City Council Special Meeting Agenda

Approve Change Order #1 for the Beacon Hill Water Tank and Water Main Extension Project

Change Order

Project: BEACON HILL WATER TANK & WATER MAIN EXTENTION PROJECT	Owner: City of Cody, Wyoming	Owner's Contract No.: 2020-01
Contract: Beacon Hill Water Tank & Water Main Extension Project		Date of Contract: May 4, 2020
Contractor: Harris Trucking & Construction, Inc.		Engineer's Project No.: 171133

WATER TANK FINISH GRADING
BEACON HILL WATER TANK & WATER MAIN EXTENSION PROJECT

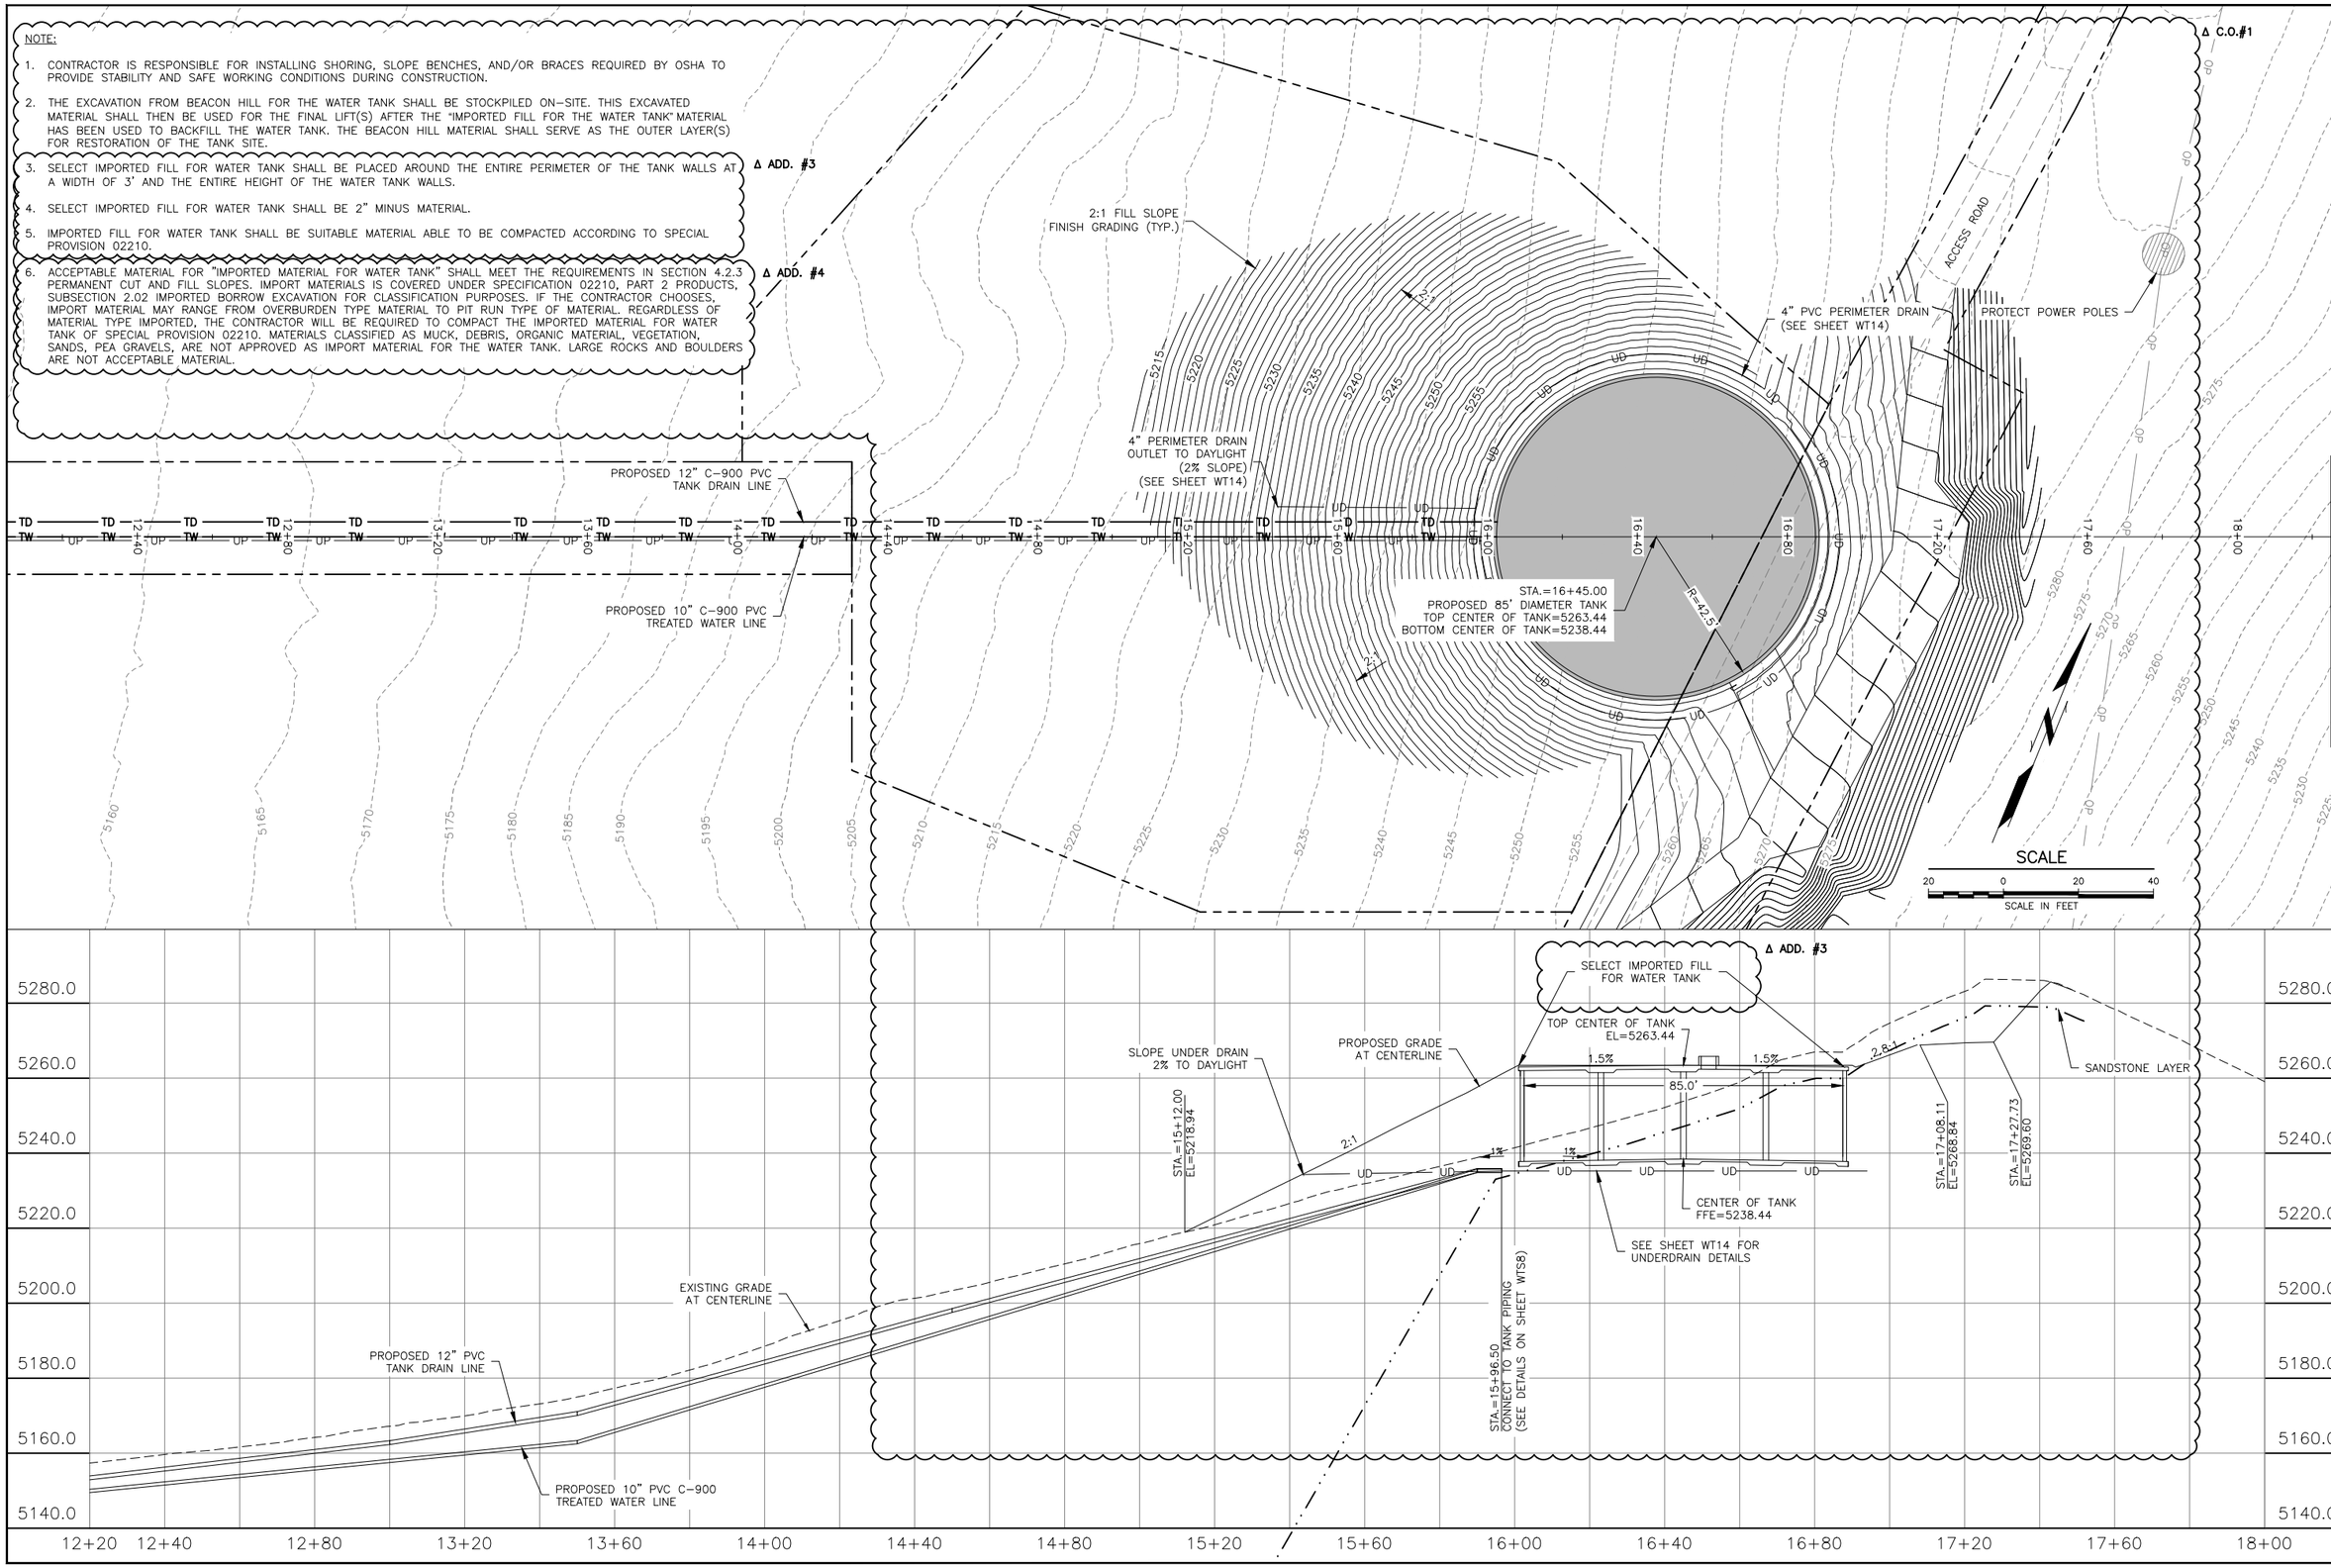
NO.	DESCRIPTION	DATE	BY:
3	ADDENDUM #4	5/11/2020	ABK
2	ADDENDUM #3	3/27/2020	ABK
1	CHANGE ORDER #1	6/18/2020	TJI

WATER TANK FENCE LAYOUT
BEACON HILL WATER TANK & WATER MAIN EXTENSION PROJECT

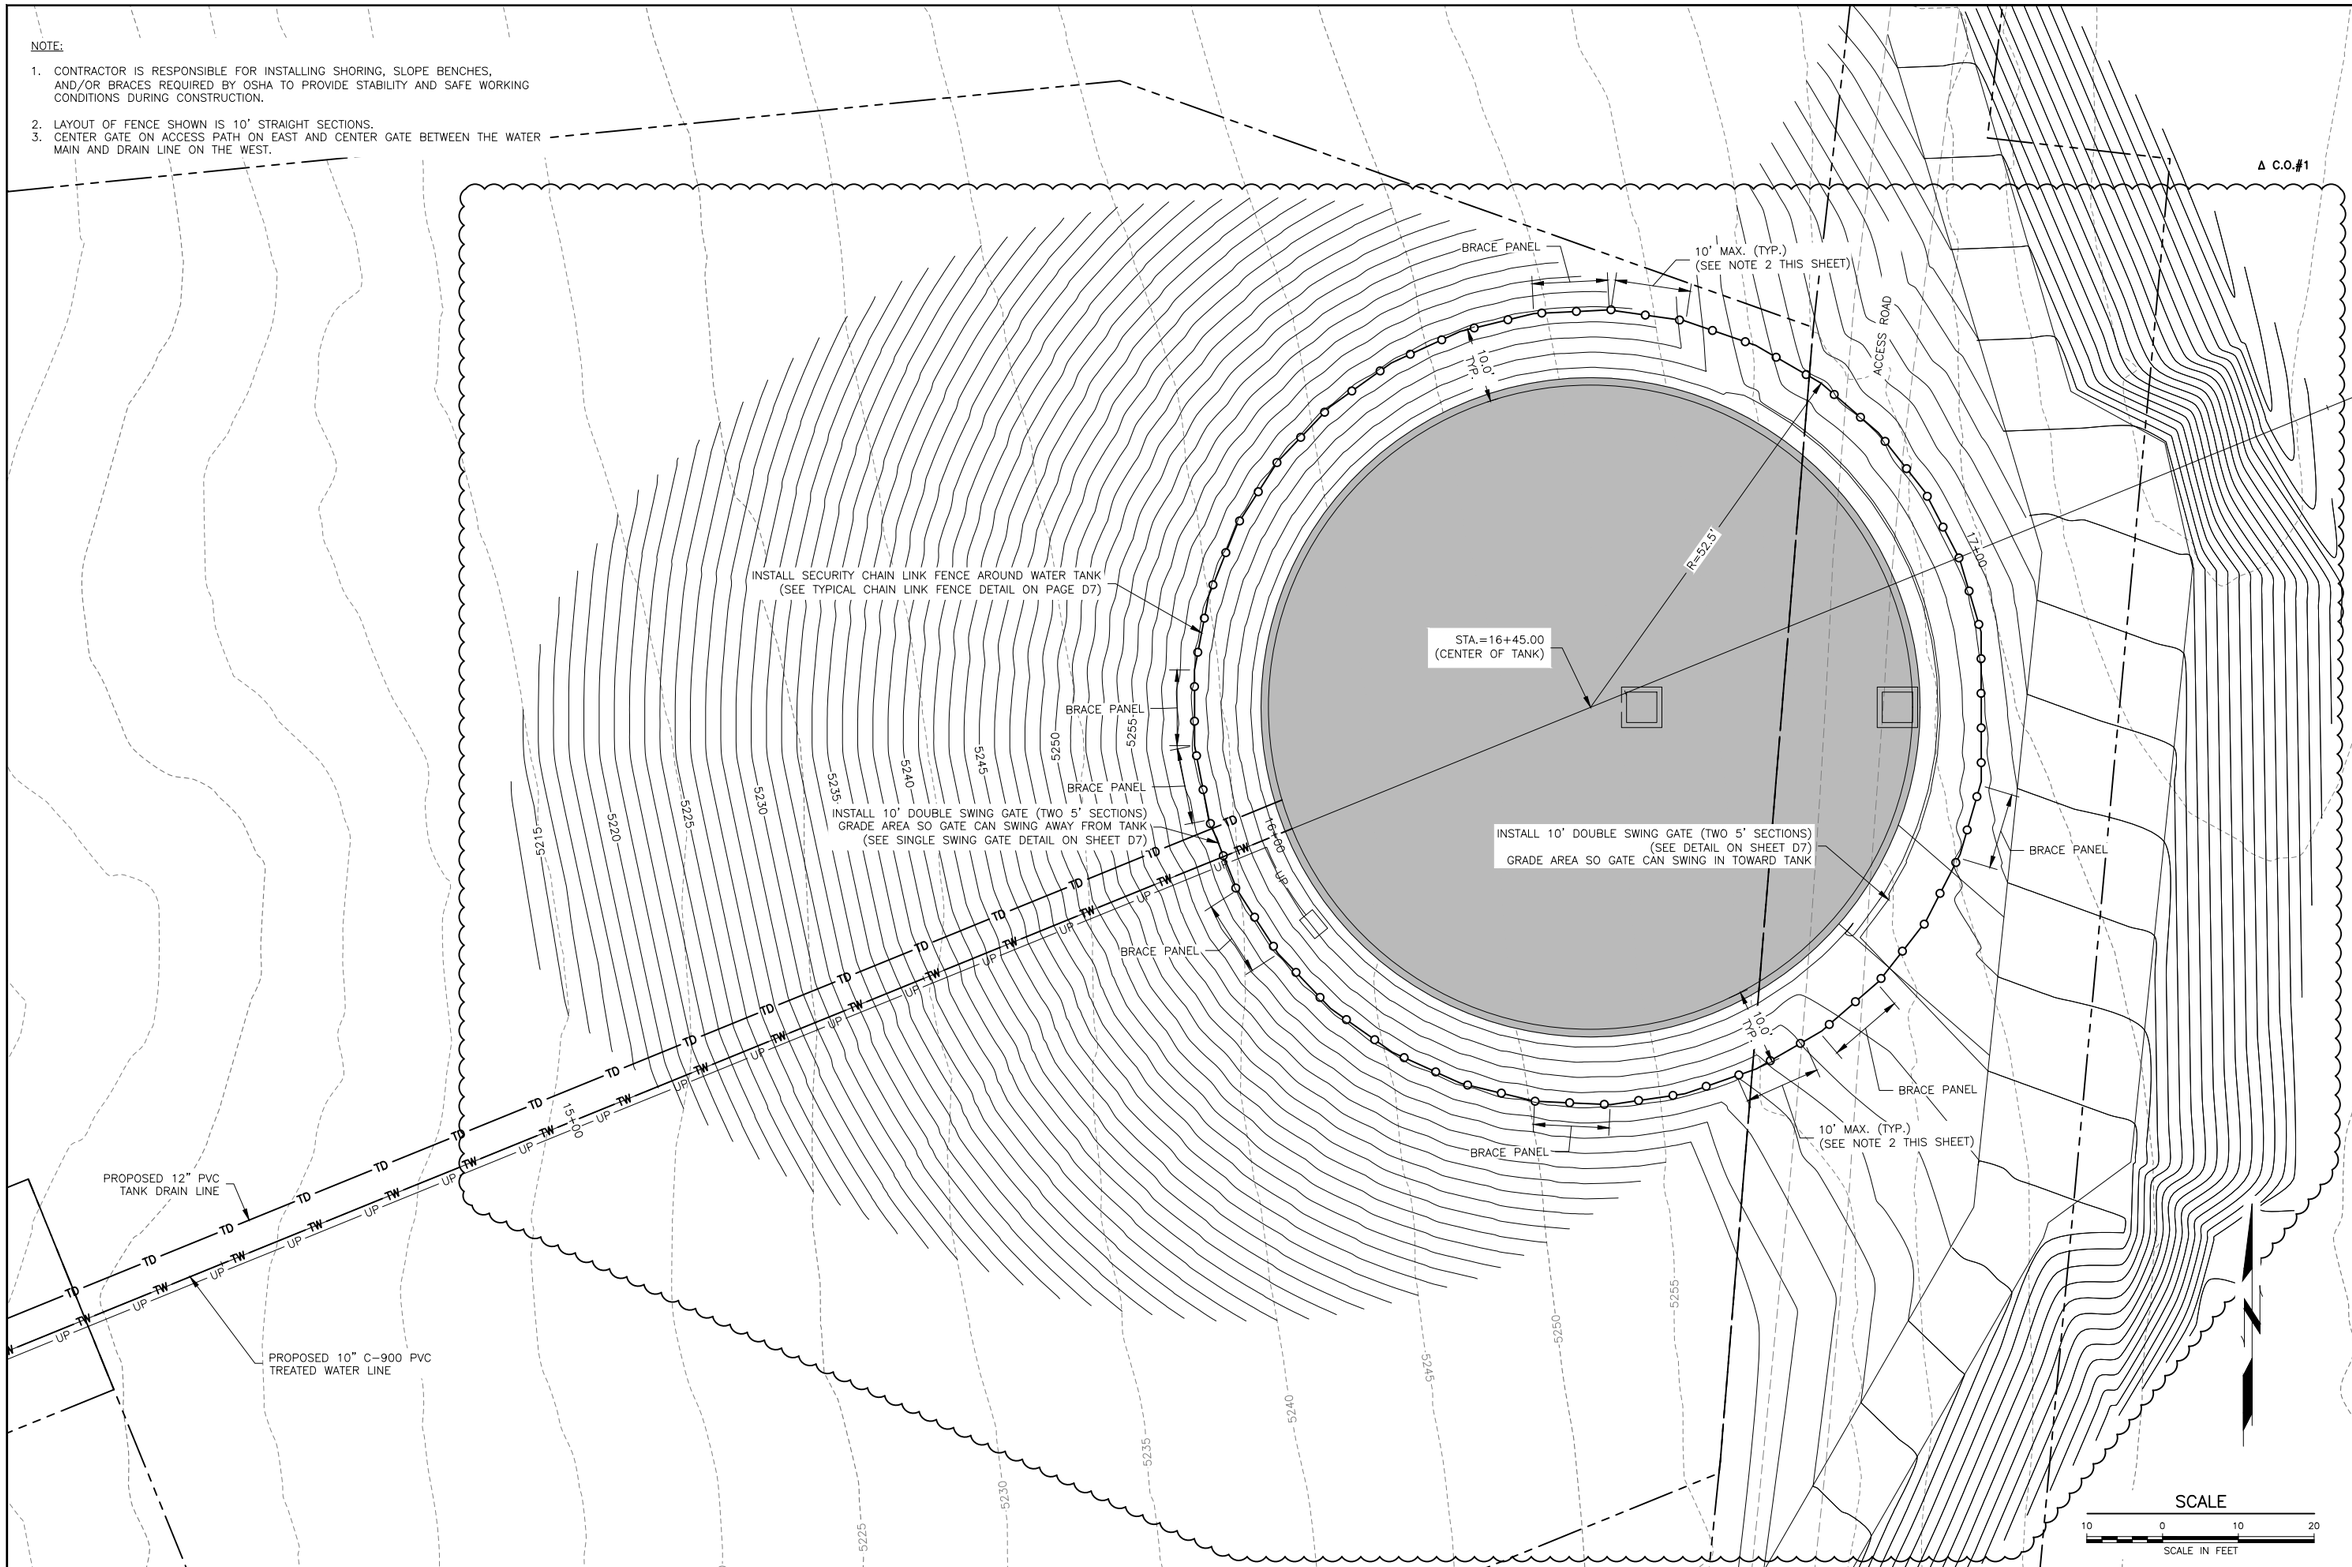
NO.	DESCRIPTION	DATE	BY:
1	CHANGE ORDER #1	6/18/2020	TJI

WATER TANK SURFACE RESTORATION AND EROSION PLAN - SHEET 2
BEACON HILL WATER TANK & WATER MAIN EXTENSION PROJECT

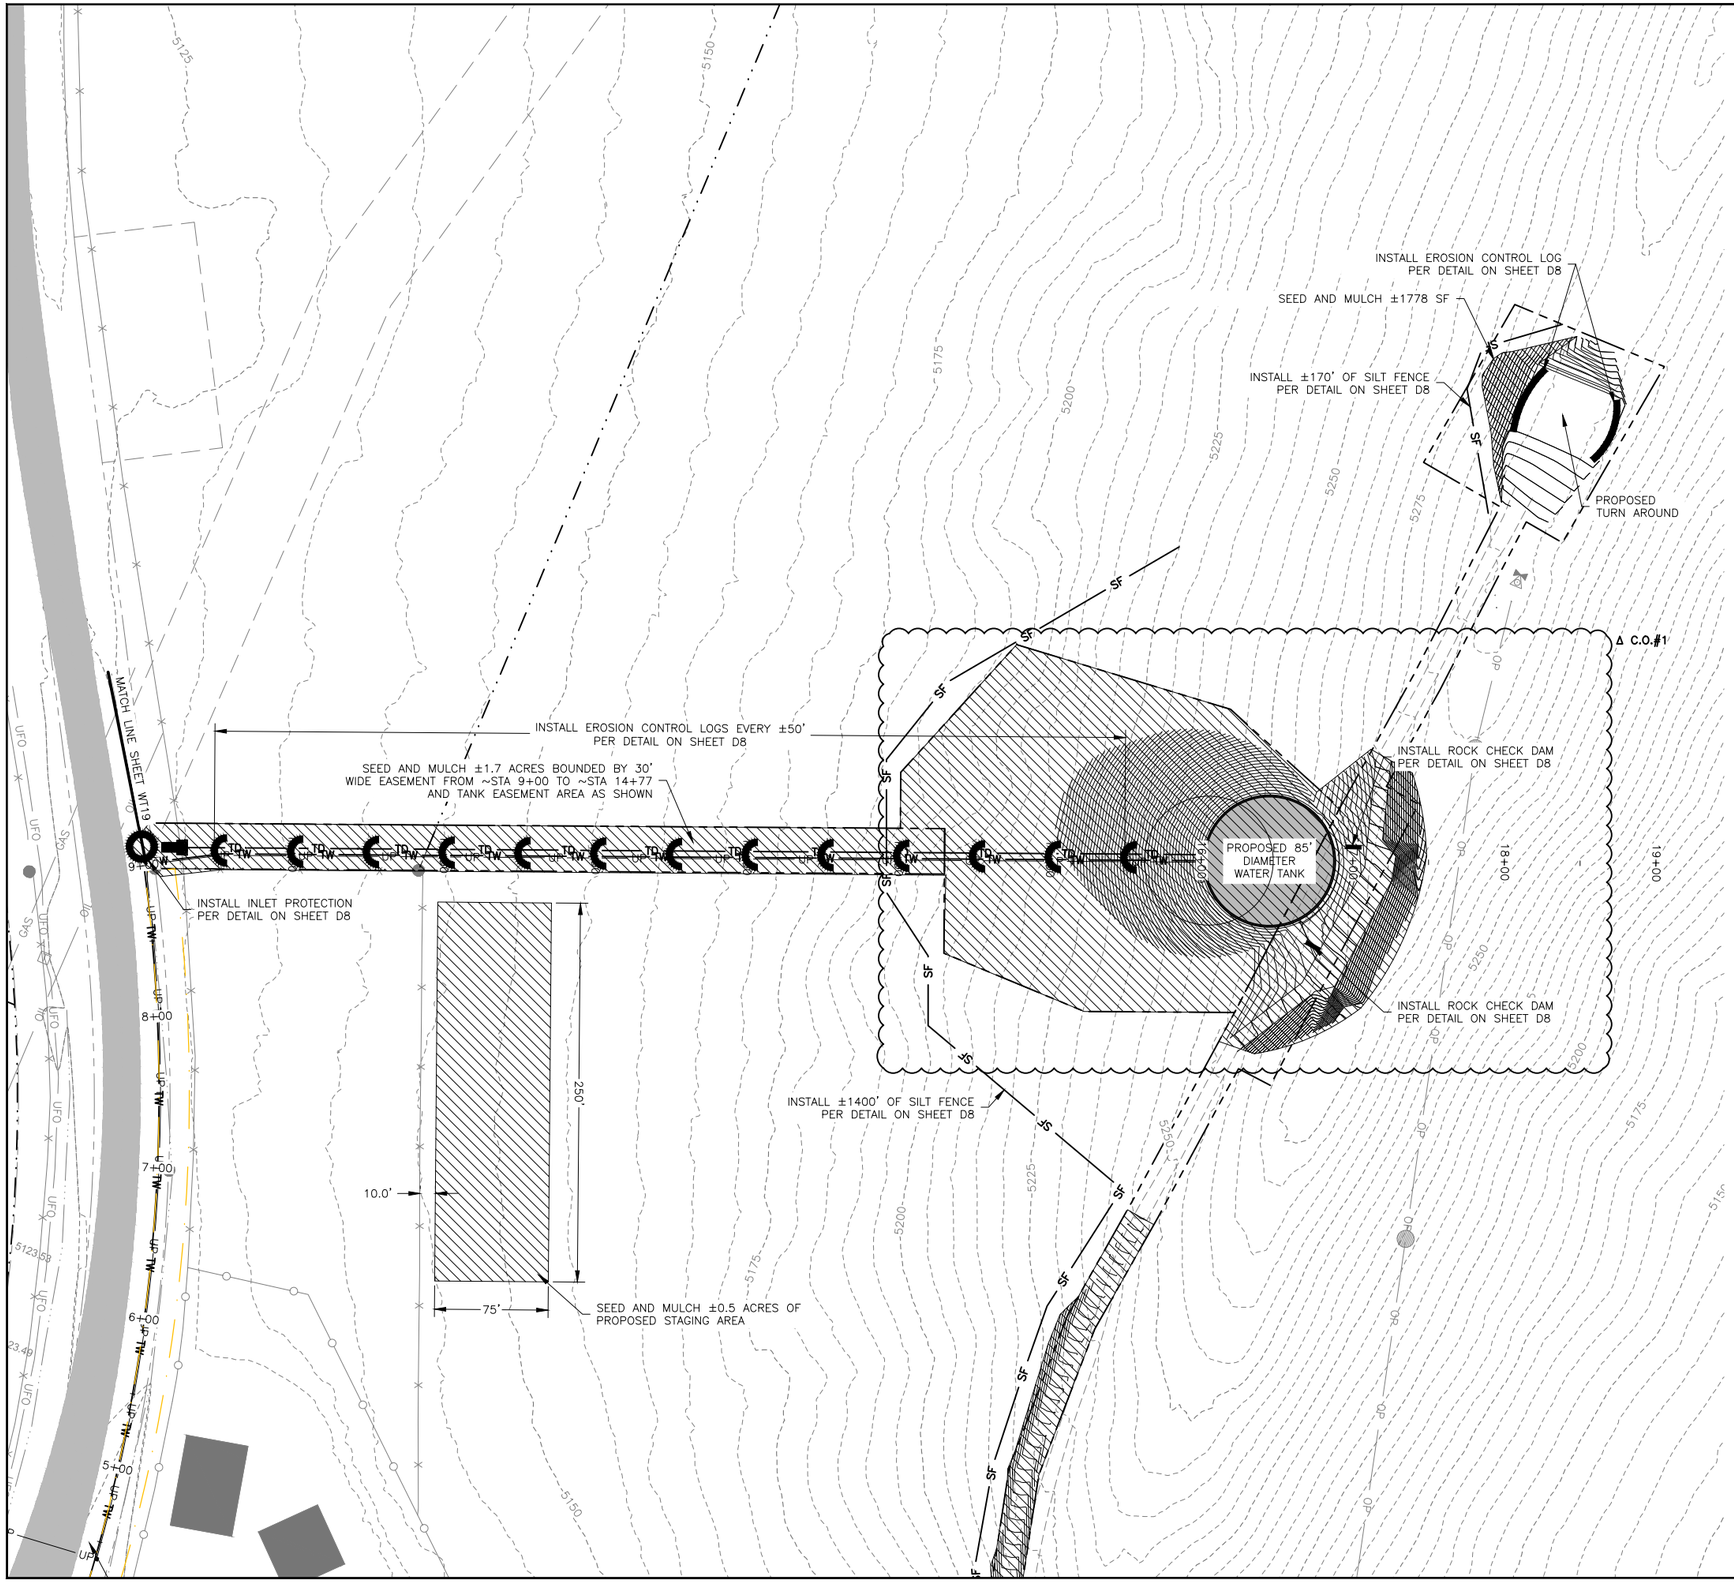
NO.	DESCRIPTION	DATE	BY:
1	CHANGE ORDER #1	6/18/2020	KES
